# **Appendix 3 Further Information Response - Ecology**

Lyrenacarriga Windfarm

Client: **Churns Energy**

Document Title: **Appendix 3 Further Information Response - Ecology**

Figure 2 Proposed Monitoring Hedgerow at T16 (Fig 6-1 EIAR Chapter 6)

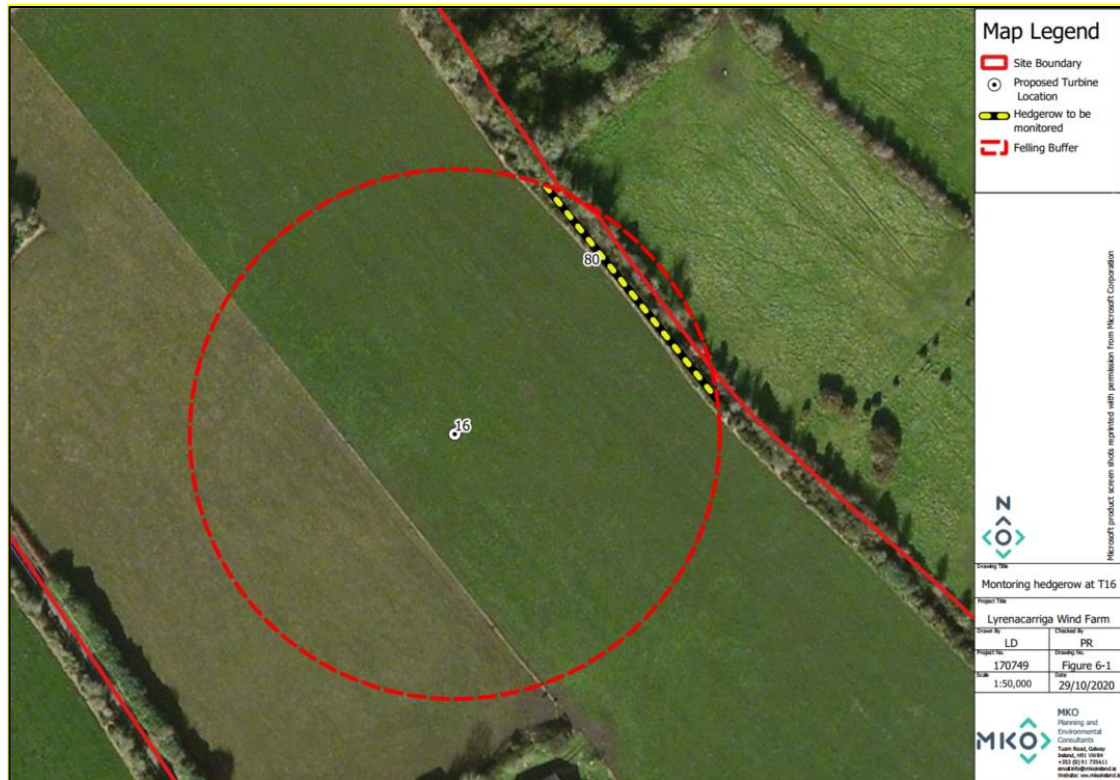
**f) Concern has been expressed that a hedgerow in proximity to turbine 16 remains within the 50m buffer zone for bats with the potential for increased mortality rates for bats at this location. Please address.**

Turbine 16 is located in the Western envelope (Figure 6-1 of the Bat Survey Report that accompanies the EIAR and provided again below). There is approximately 80.2m of hedgerow located to the east of this turbine that falls within the 50m felling buffer of the blade width. This hedgerow is not proposed to be felled as it runs along the site boundary. It is the opinion of MKO that it would be premature to remove this section of hedgerow, based on the potential for its retention to result in bat fatalities. An image of this section of hedgerow is provided in Plate 1-1 below and its location in relation to T16 is shown in Figure 6-1 of the EIAR bat survey (provided below).

As specified in the EIAR, the turbine will be monitored post construction. Monitoring will be completed in line with the post construction monitoring proposal for the site, as detailed in section 6.2.1 of the Bat Survey Report that accompanies the EIAR. Monitoring will be conducted in line with SNH guidelines and comprise of static monitoring at turbine bases and at nacelle level. Carcass searches, to monitor and record bat fatalities shall take place at each turbine. If significant bat fatalities are recorded, adaptive mitigation in the form of bespoke curtailment or removal of the hedgerow will be undertaken.

However, in the light of the concerns raised in the Further information request, it is recognised that An Bord Pleanála may determine that it is more appropriate to remove the hedgerow and therefore to minimise any associated potential for effects on bat species as a result of collision with T16.

To conclude, in relation to the concern expressed over a section of hedgerow to be retained within the 50 meter buffer of Turbine 16, it is the opinion of MKO that it would be premature to remove this section of hedgerow, based on the potential for its retention to result in bat fatalities. However, if An Bord Pleanála deemed it more appropriate to remove the hedgerow to minimise any associated potential for effects on bat species as a result of collision with T16, the appropriate amendments have been made to Tables 7-14, 7-17, and 7-20 of the EIAR and are given above. These amendments account for the additional loss of approx. 80.2 meters of hedgerow.
